# Memorandum

**Re:** Work Session for Hardware Village II – Design Review  
Petition PLNPCM2022-00586

**Property Address:** 152 N 500 W

### **Building Setbacks**

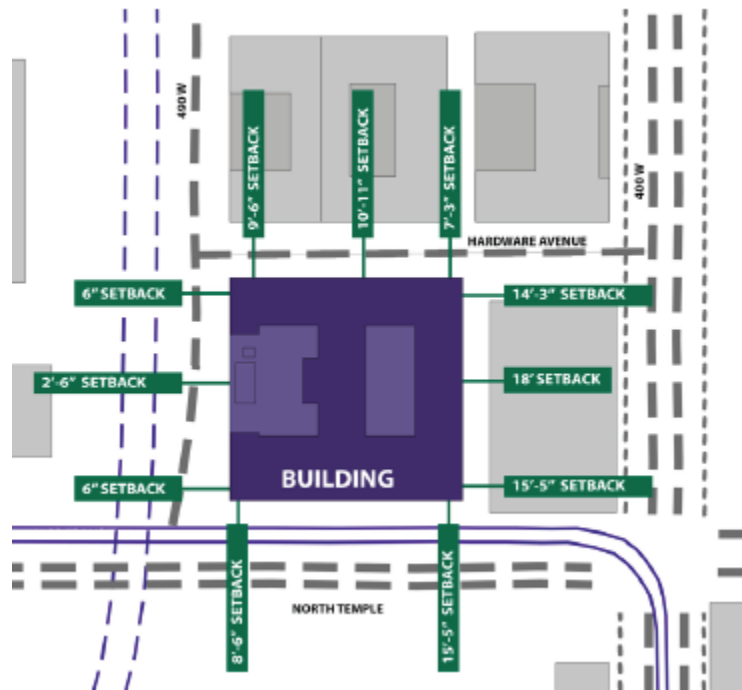
Hardware Ave: ranging from ~7 feet to ~11 feet, 0% is within 5 feet of the property line.

North Temple: ranging from ~8 feet to ~16 feet, 0% is within 5 feet of the property line and no plazas, courtyards or outdoor dining is proposed at the ground level.

Hardware Avenue is being proposed to have on-street parallel parking, with the proposed parking and sidewalk the building needs to be pushed back. Staff has the opinion that the setbacks along Hardware Avenue accomplishes an activated sidewalk that includes commercial space, residential units and a plaza area.

The existing at grade sidewalk along the North Temple viaduct/overpass abuts the property line of the subject property and the wall of the viaduct/overpass. Having the proposed building pushed back further from the property line creates a wider corridor instead of a narrow corridor between two large walls that would create an uncomfortable space. Staff agrees that the building setback needs to be push back further from the property line in order to make the space more comfortable to the public and future residents.

### **Ground Floor Use and Visual Interest**

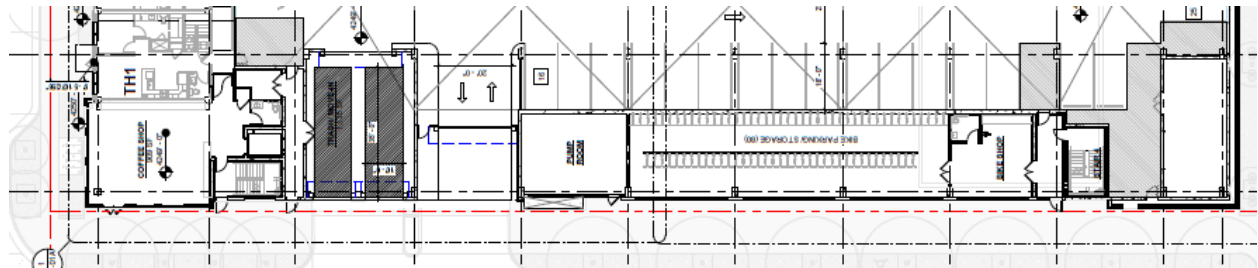
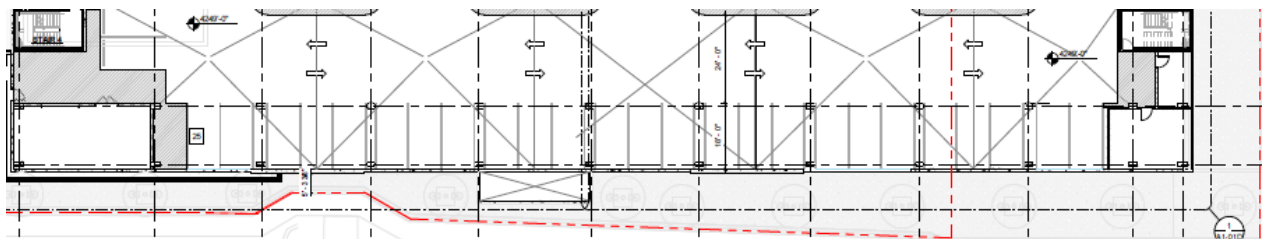
The 490 West facade faces the North Temple Frontrunner Station and the elevator/stairs that access the North Temple Bridge/Guadalupe Trax stations. The corner of 490 West and Hardware Avenue is proposed to include 909 SF of commercial space, ~10% of the ground floor. The ground level detail does include a variety of building materials, architectural features, and façade changes. It also includes a bicycle shop and storage area for residents and public transit users to utilize.

However, the main use of the interior is the proposed parking garage. Staff is of the opinion that the bicycle shop and storage area should be built to commercial standards so in the future the space can be converted into commercial space, but as proposed now it is meeting the intent of this design standard.

The North Temple ground floor level use is the interior parking garage. As proposed there is no visual interest to facilitate pedestrian interaction with the building on this façade. The applicant is requesting that this requirement not be applicable, due to the nature of the grade change between North Temple and the project site. Staff is of the opinion that this façade does face the public realm and therefore should incorporate these design requirements.

North Temple Elevation

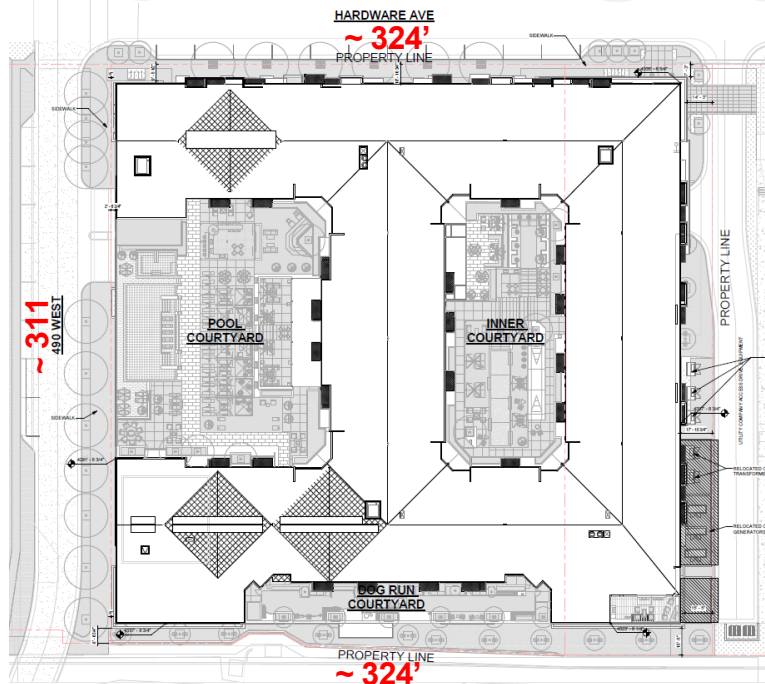
entrances. The applicant is seeking to modify the required number of entrances to 4. It is Planning Staff's opinion that the intent is being met for 490 West based on the proposed commercial space, bicycle parking area and parking garage entrance engages the public sphere as intended.

The applicant is proposing zero operable building entrances along North Temple, the required amount for this facade is 8 operable building entrances. There are no proposed building access points or commercial uses that would require an entrance along North Temple, the interior uses along this facade are the parking garage and building utility areas. In regard to the public space along this facade, it is staff's opinion that the intent of this standard is not being met because it is not engaging the public sphere as intended.
